### **REMARKS/ARGUMENTS**

**Amendments to the Drawings:**

The attached eight (8) sheets of drawings include changes to Figs. 1-3, 8, 9, 11, 13, 15 and 16. These eight sheets replace the original sheets including Figs. 1-3, 8, 9, 11, 13, 15 and 16. The changes are detailed below:

**FIG. 1**

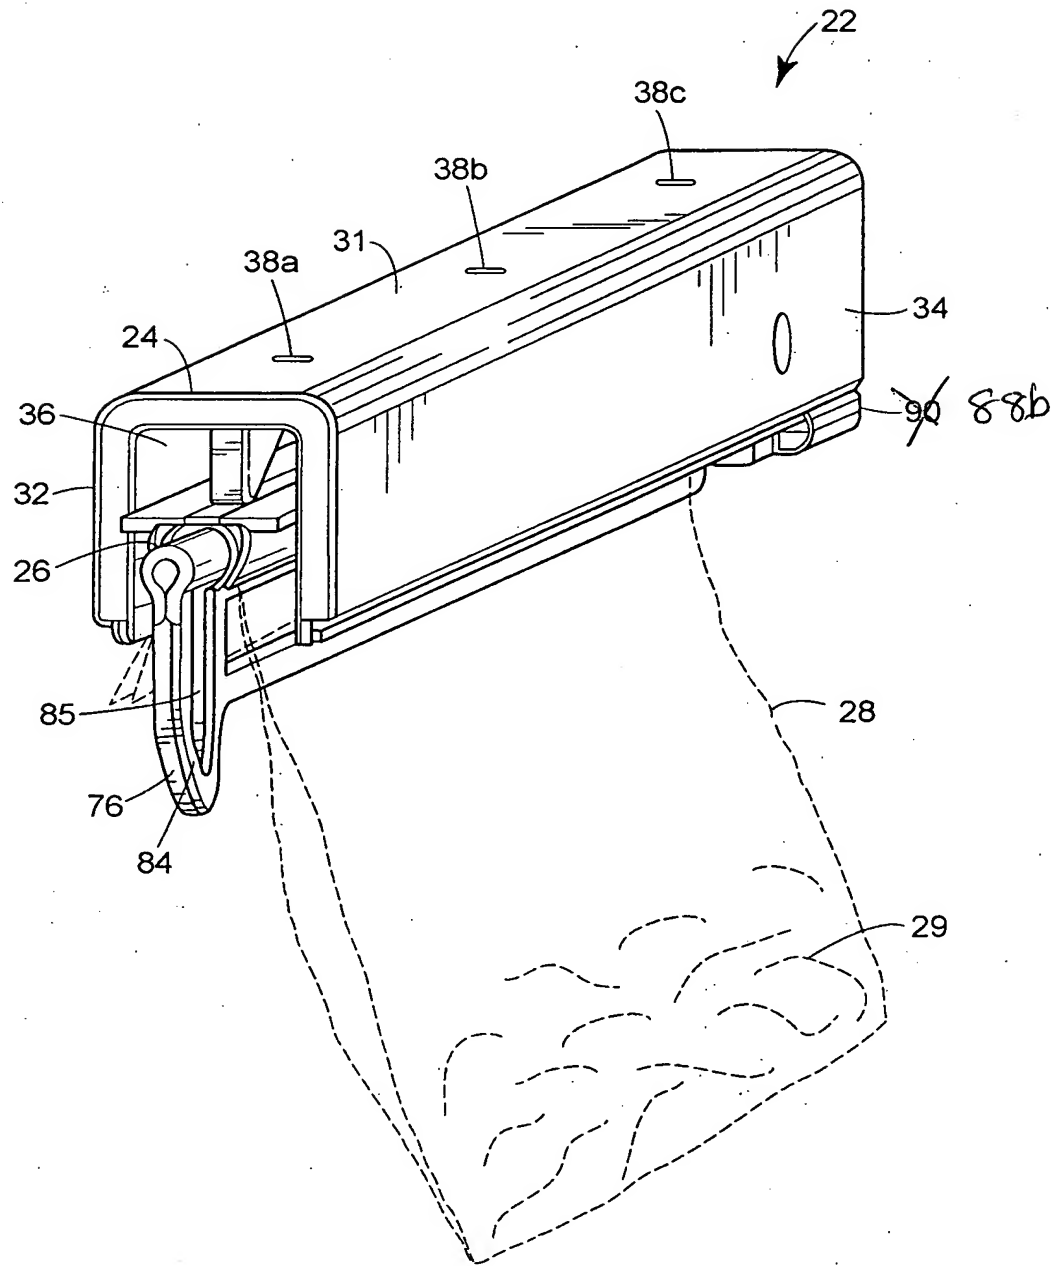
In Fig. 1, "90" has been changed to --88b--.

**FIG.2**

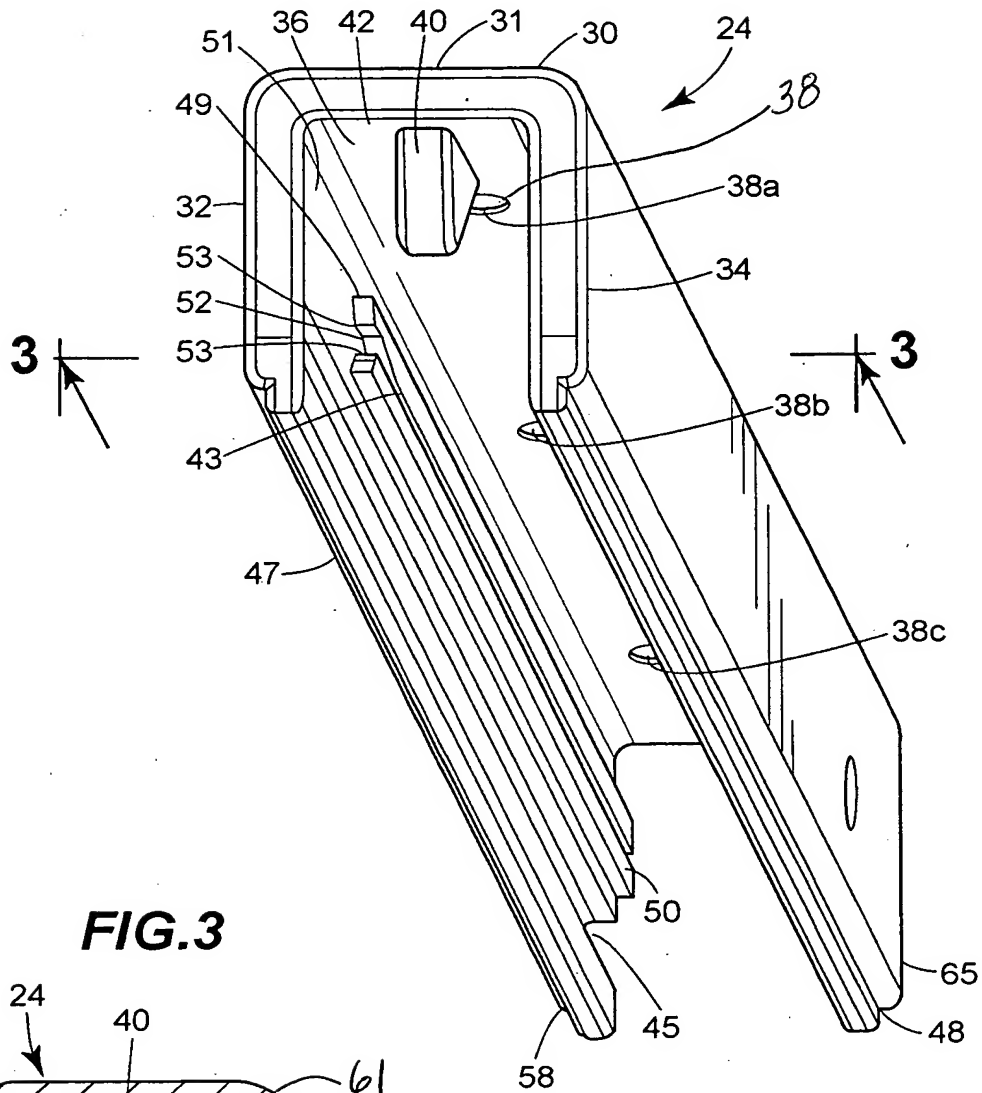
In Fig. 2, "38" has been added;

**FIG.3**

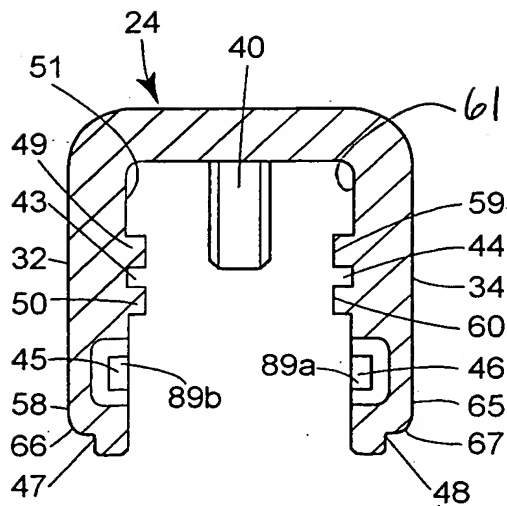
In Fig. 3, "61" has been added;

FIG. 8

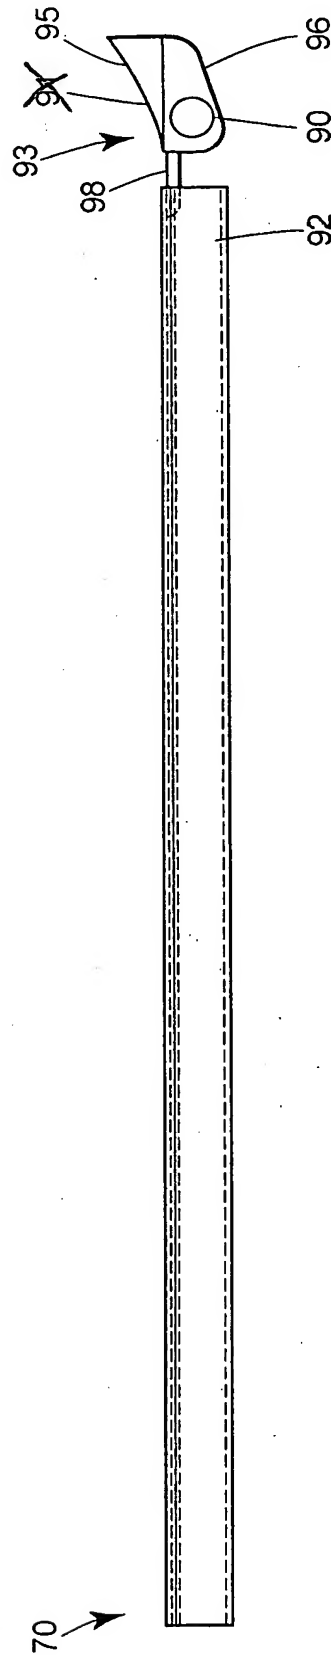
In Fig. 8, "91" has been deleted;

FIG. 9

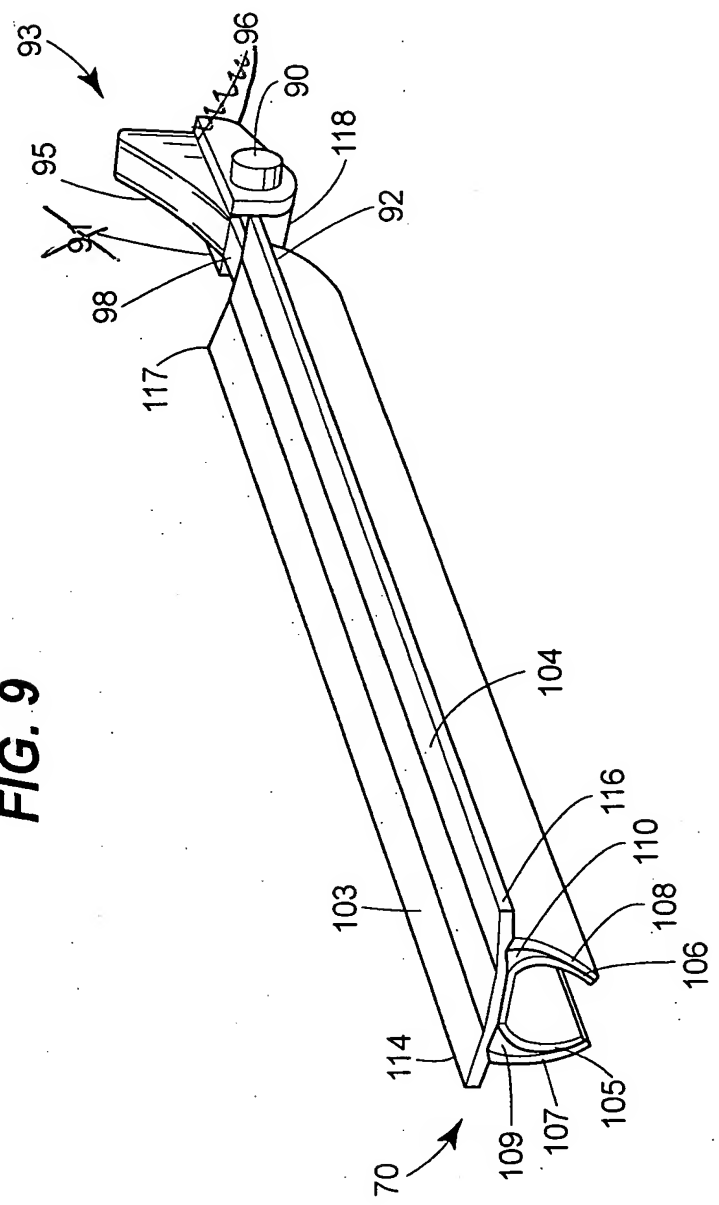
In Fig. 9, "91" has been deleted and the lead line from 96 has been moved;

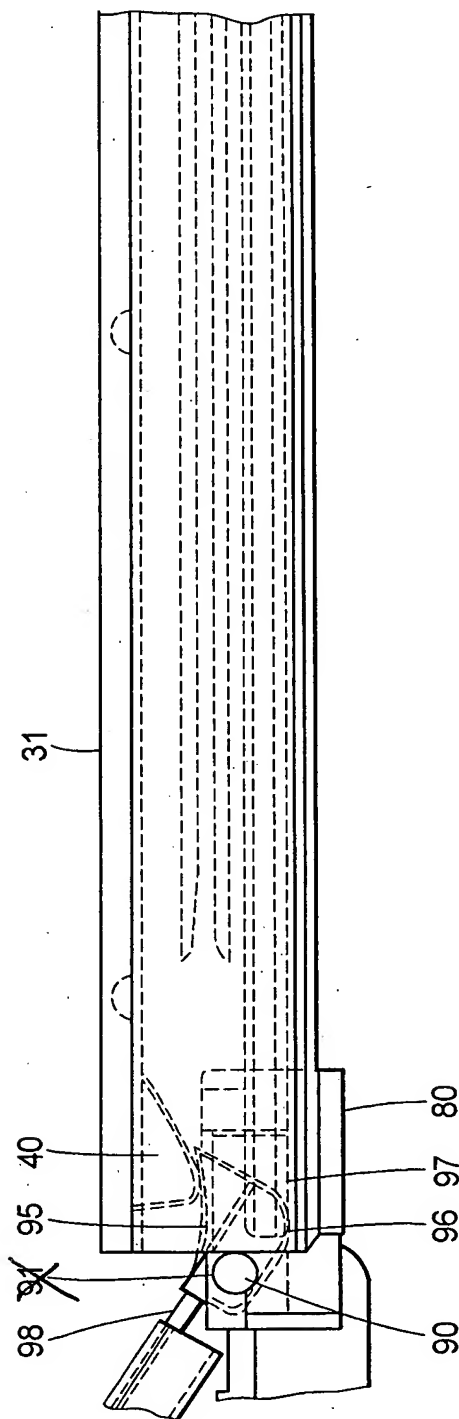
In Fig. 11, "91" has been deleted.
